**Re: Application for Site Plan Approval at 657 Saw Mill River Road  
(a/k/a Parcel No. 6.50-35 Lots 8, 9, 10, and 11)**

We are pleased to provide responses to the Village Consultant and NYSDOT review memorandums along with Board of Trustee and public comments. A digital copy of the full submission package will be provided to the Building Department via email. Accordingly, we have provided the below materials and responses for your consideration to be discussed at the next Town Board Meeting.

**MEMO from David B. Smith of Planning & Development Advisors –  
Site Plan Review 657 Saw Mill River Road  
December 12, 2023**

Drawn: **KRM** Approved: **RJP**  
Scale: **1" = 10'**  
Date: **05/26/2020**  
Project No: **18175**  
1815-SE C-300-UTIL UTIL.dwg  
Drawing No:  
**C-300**

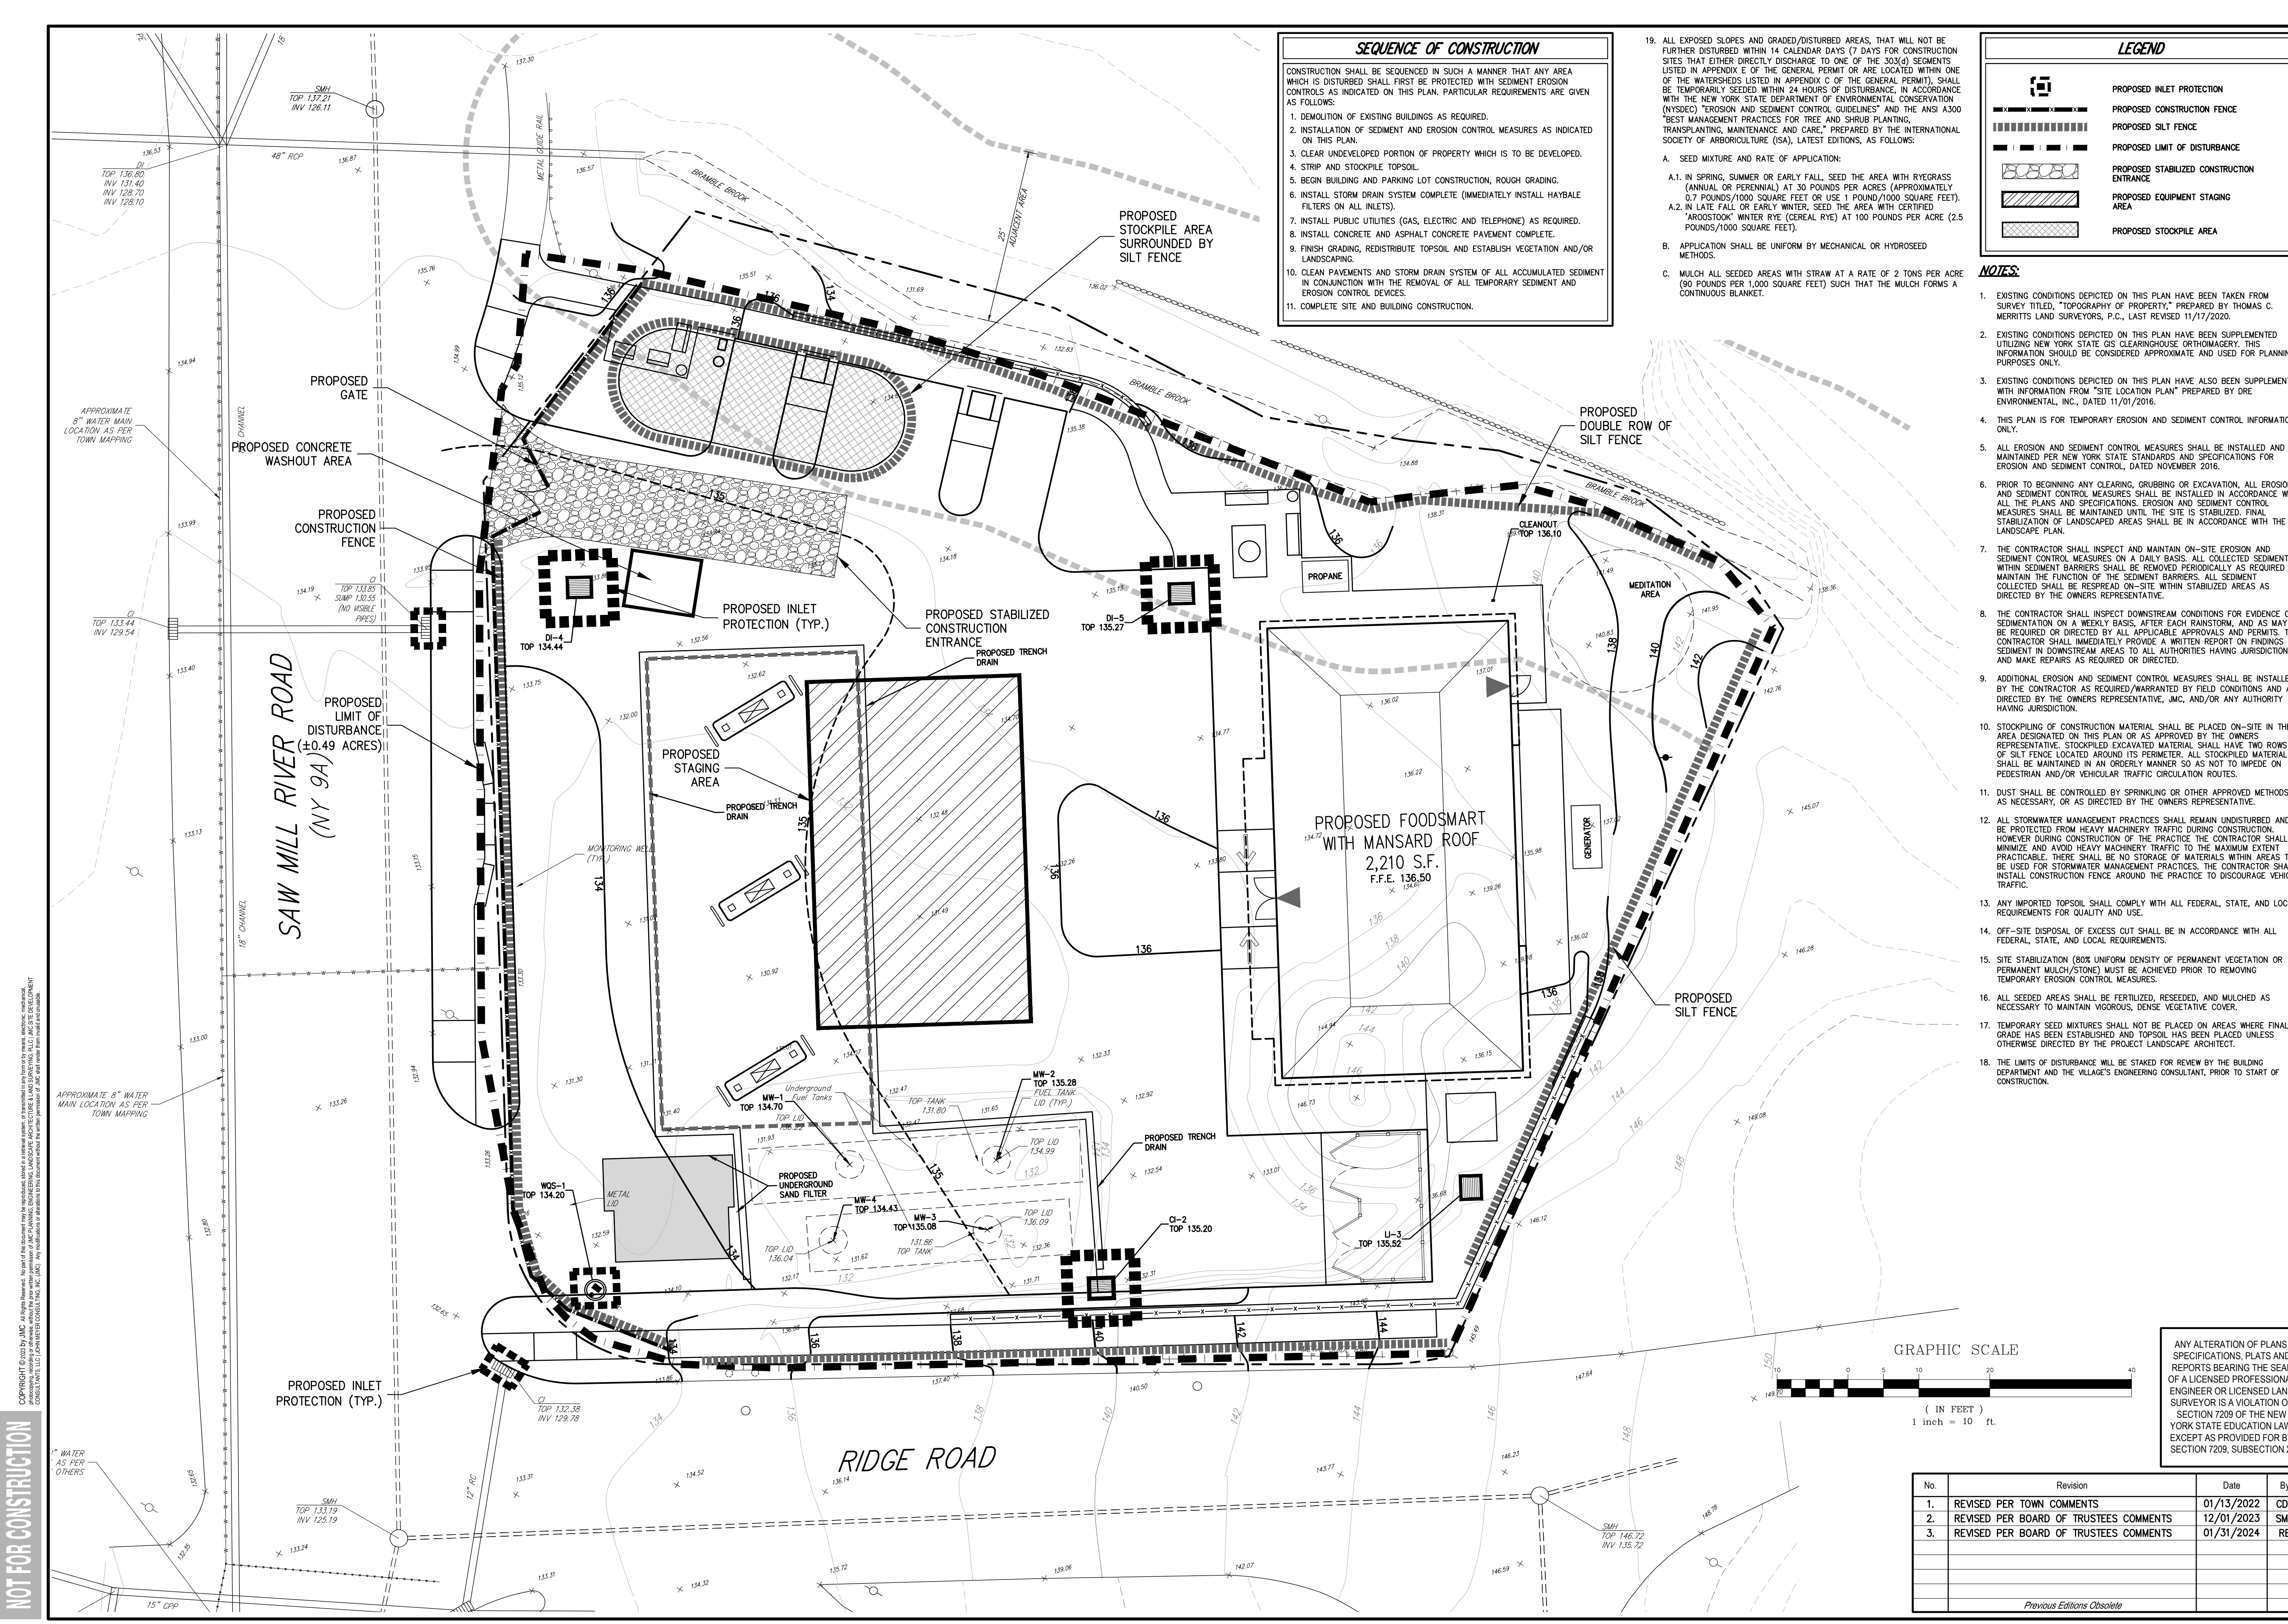
**Comment C.** The Utilities Plan should include the locations of the fueling canopy drain discharge locations.

The locations of all fueling canopy drain discharge locations are now shown on the JMC Drawing C-300.

Drawn: **KRM** Approved: **RJP**  
Scale: **1" = 10'**  
Date: **05/26/2020**  
Project No: **18175**  
Drawing No: **C-600-LIGHT** LIGHT.scr  
**C-600**  
*Previous Editions Obsolete*

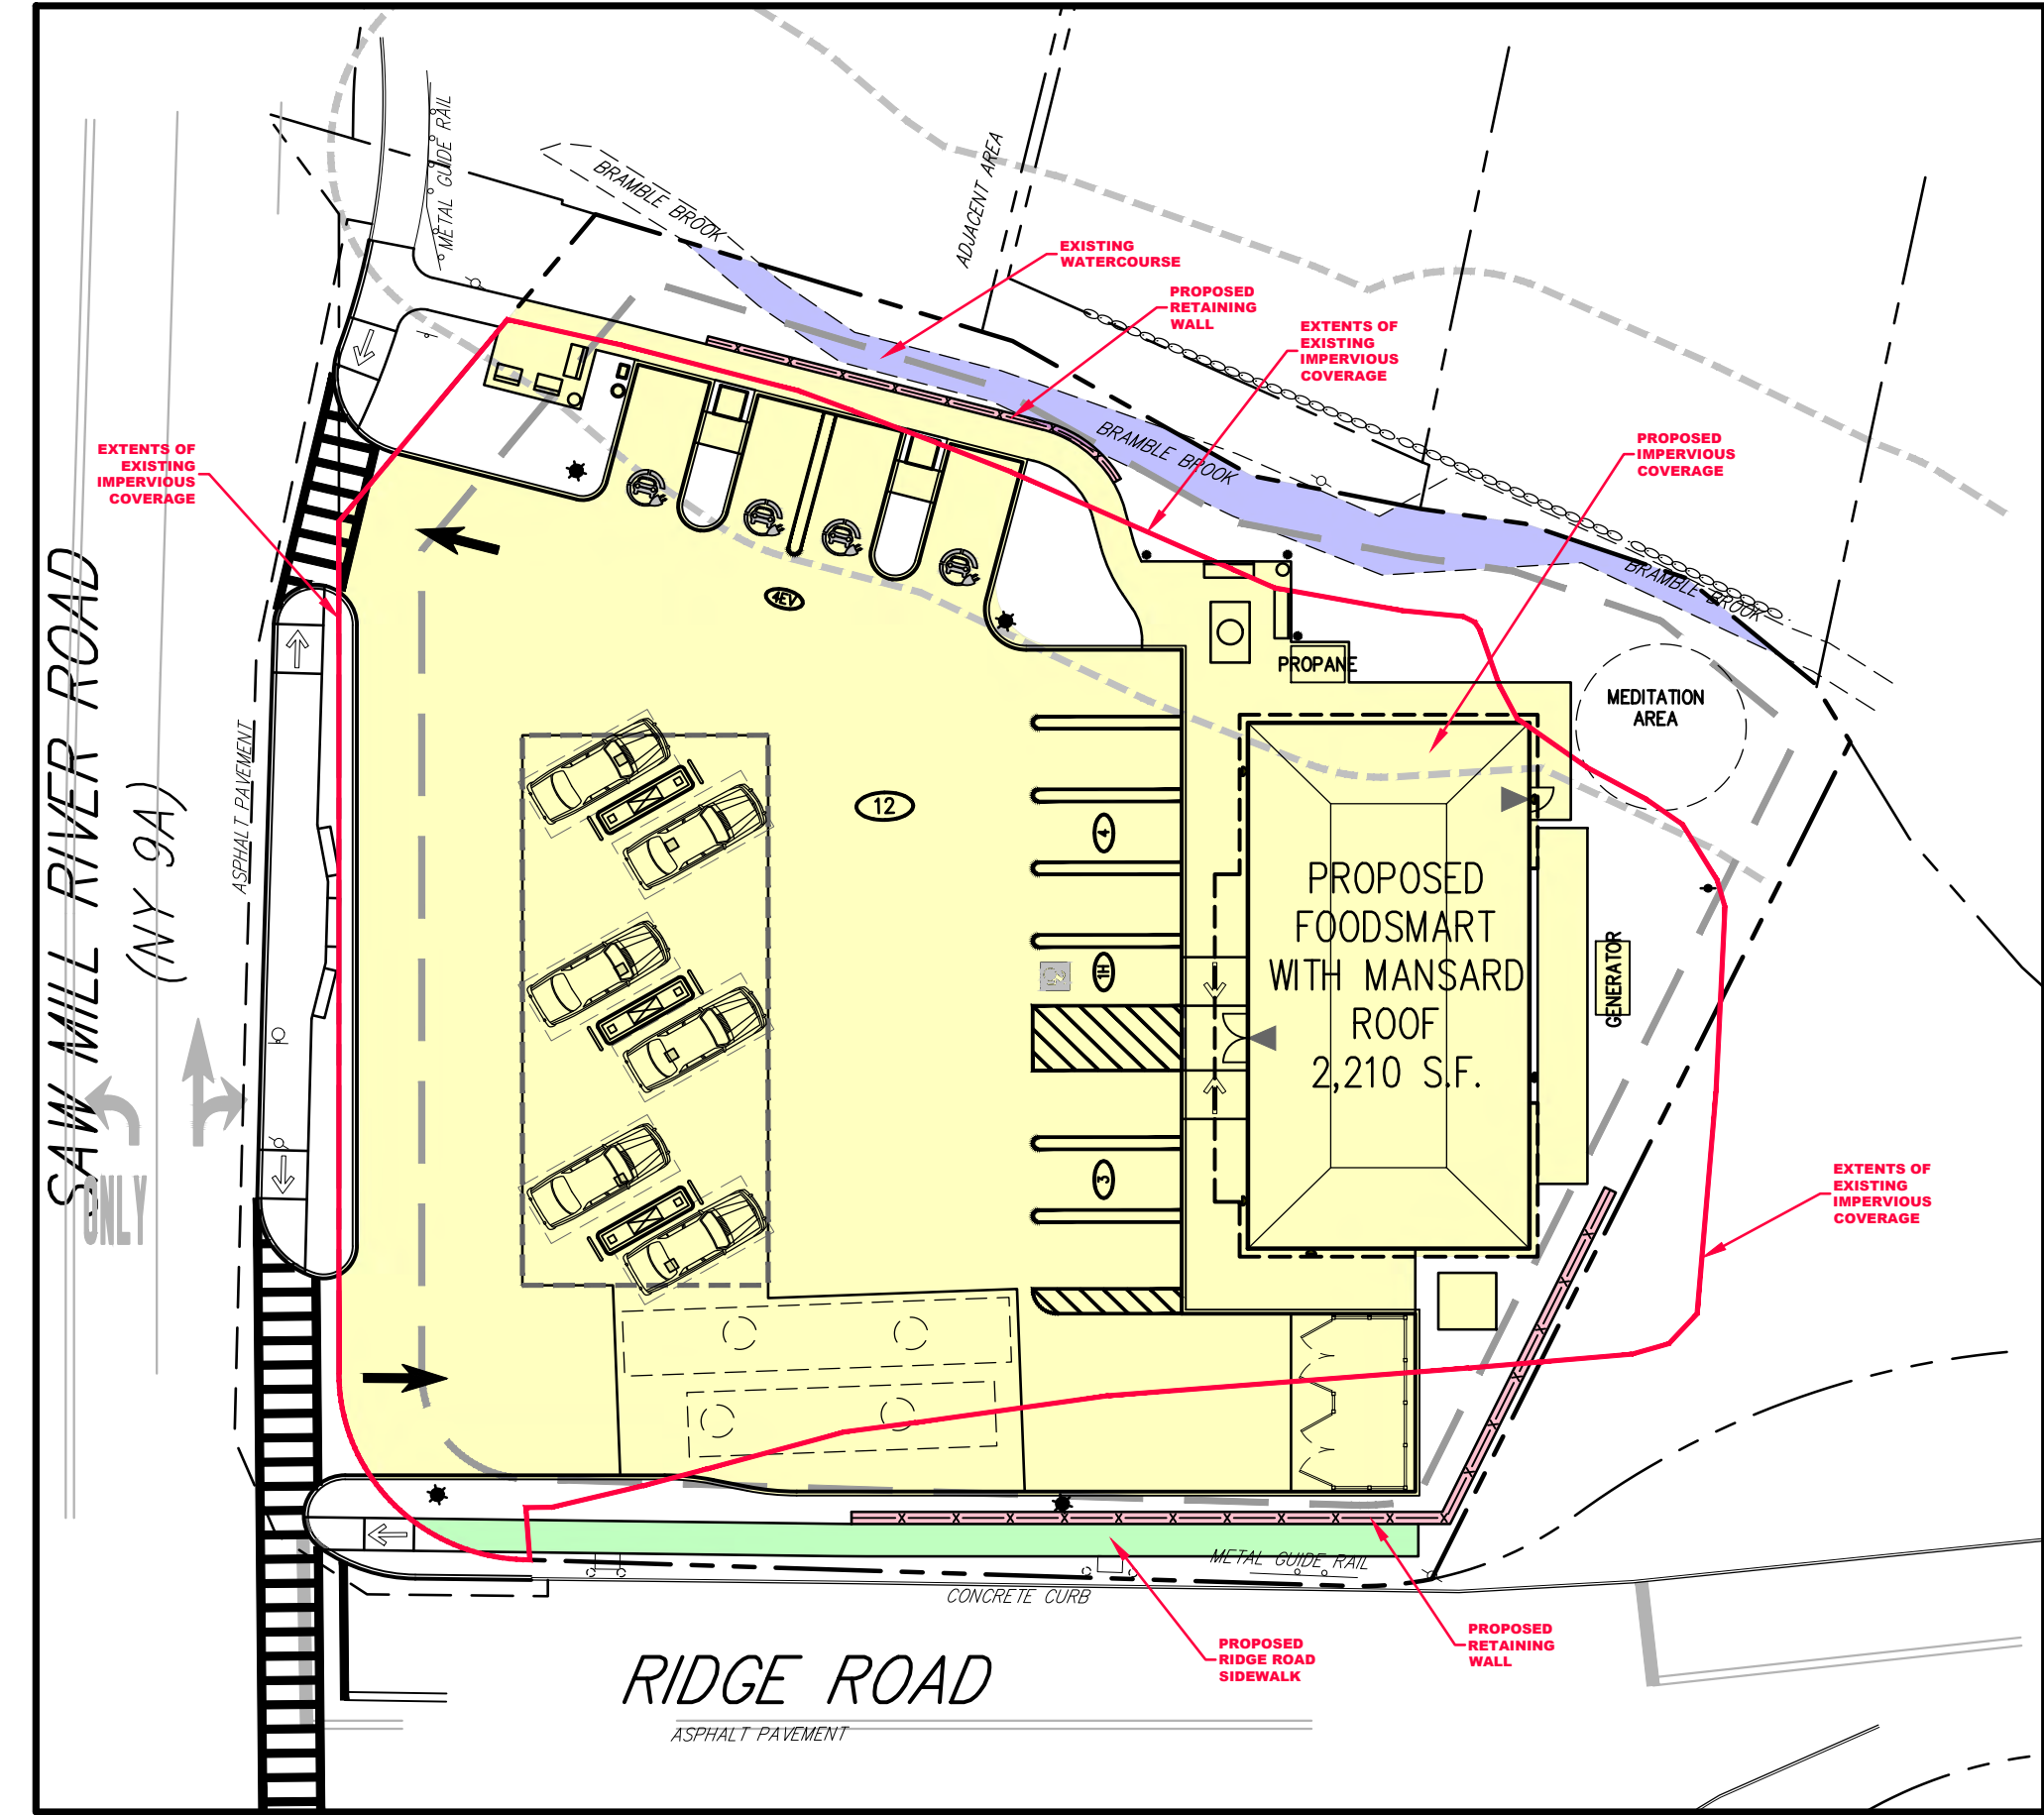
**Comment 1.** The applicant has provided a lighting plan and lighting details for the Board's consideration. We note that some light trespass is shown beyond the applicant's property towards the residential district to the east. The light causing the issue appears to be mounted in the vicinity of the southeast side of the building. The applicant should examine mitigating the spillage onto the neighboring property.

Upon approval of the updated layout, the applicant will finalize the lighting plan and will ensure that no light spillage will occur on the adjacent residential properties. Note #5 has been added to JMC Drawing C-600 that states: "ALL PROPOSED LIGHTING SHALL BE DARK SKY COMPLIANT".
